**MEETING MINUTES**

PROJECT: Bayfront Parkway Improvements Project  
 MEETING: Holland Street Pedestrian Bridge Peer Review Meeting  
 DATE: March 25, 2021  
 TIME: 3:00 PM – 4:30 PM  
 LOCATION: Virtual Meeting via Teams Web Conference

# BAYFRONT PARKWAY IMPROVEMENTS PROJECT

## PEDESTRIAN BRIDGE OVER BAYFRONT PARKWAY

# Initial Concept - Review Summary

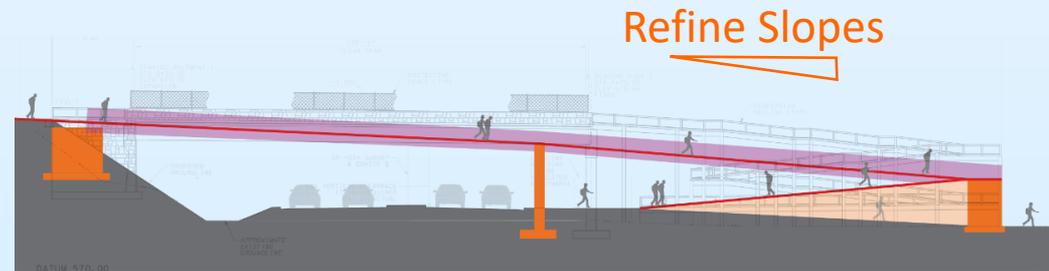
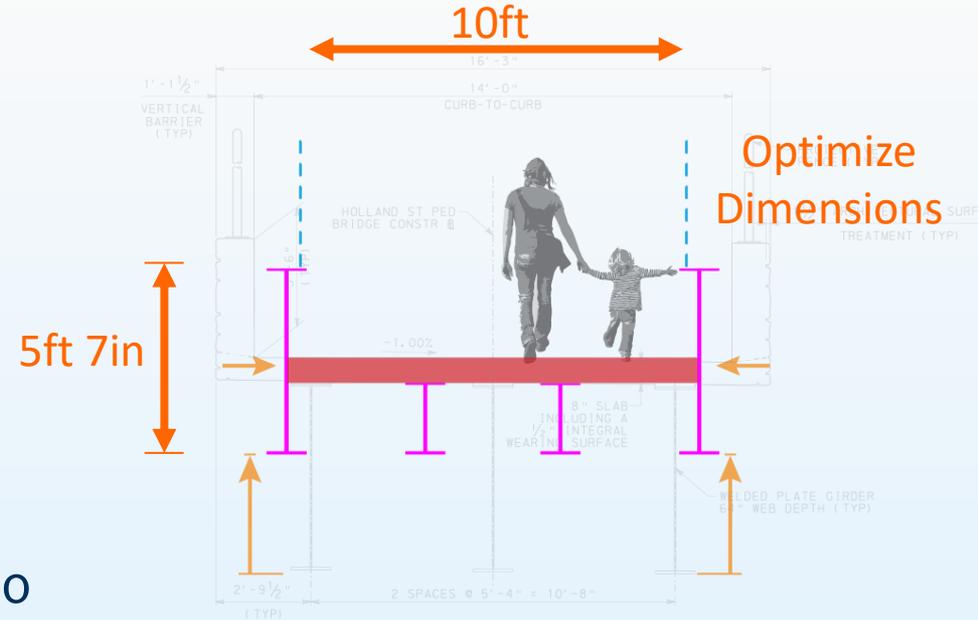
- Current estimated cost for initial main span and approach is \$4.1M
- Bridge cross section inefficient
  - Barrier proposed is not economical due to weight
  - Deck width greater than approach path width
  - Girder layout can be optimized
- Ramps set to maximum slope with no cushion for construction variances
- Angular layout compromises bridge function and experience

# CONCEPT 2 | Steel Truss

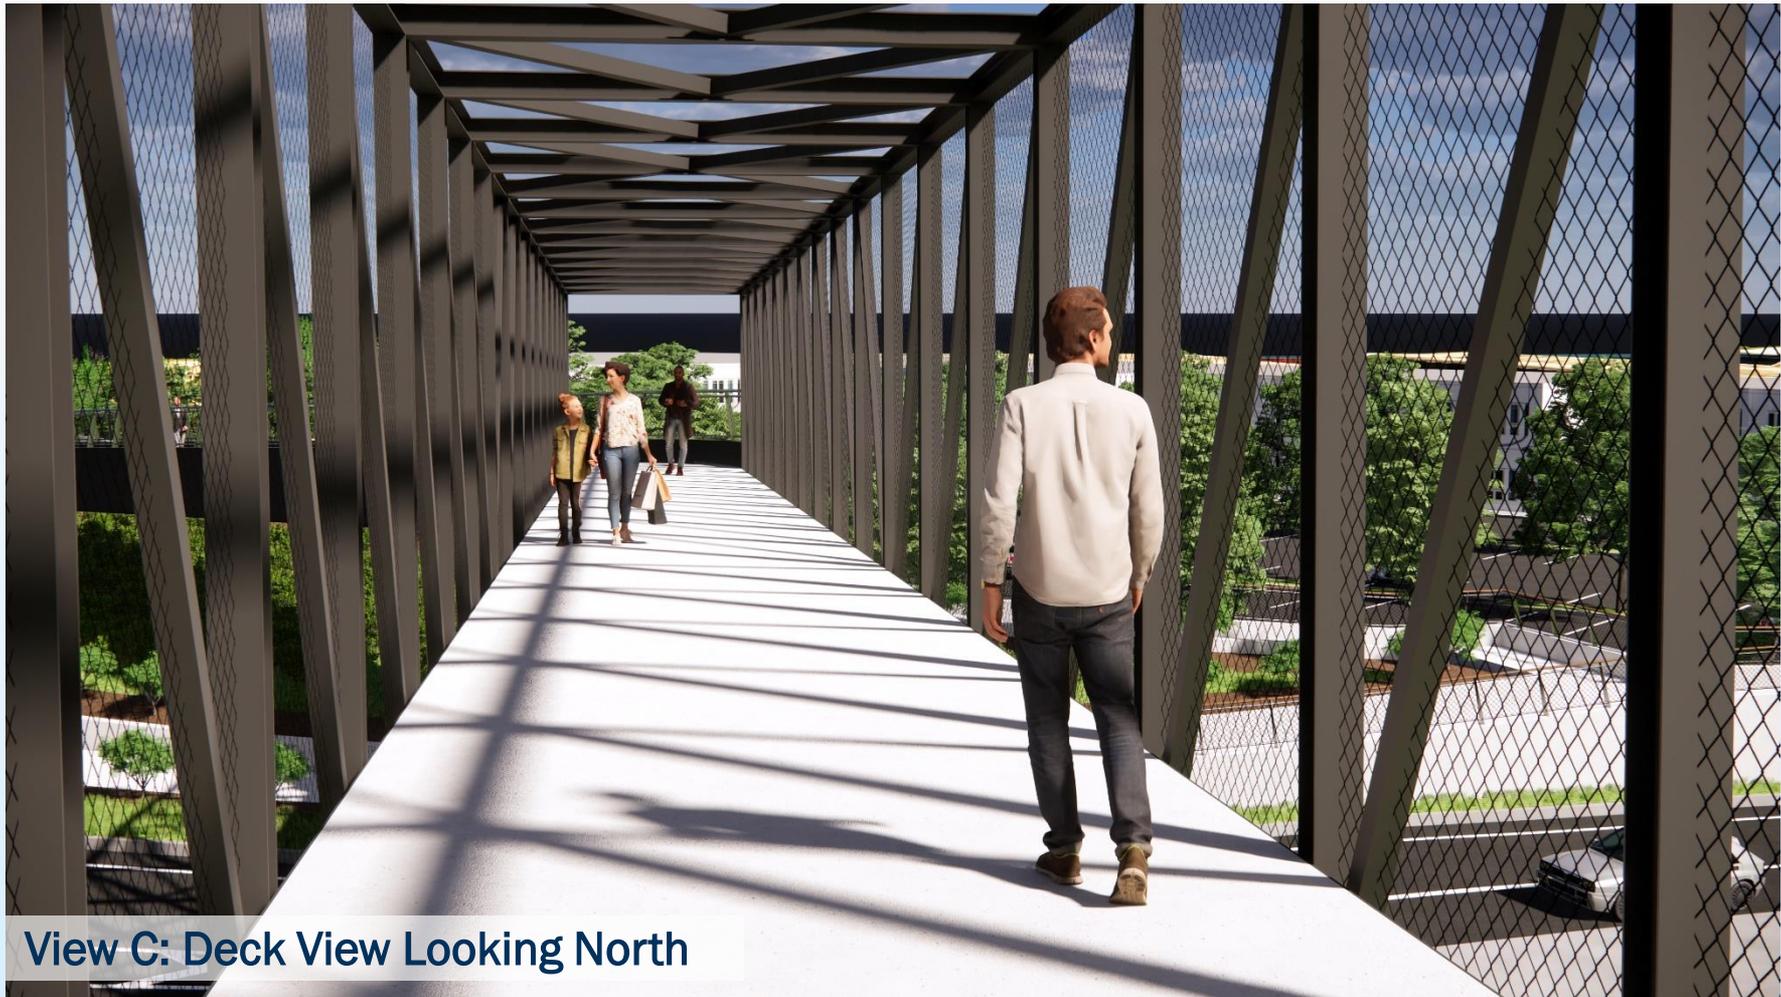
6. Kathy Dahlkemper (Erie County) – The Truss concept looks a bit frightening for those with fear of heights. Usually, a bit of solid side walls gives people a bit of personal security.
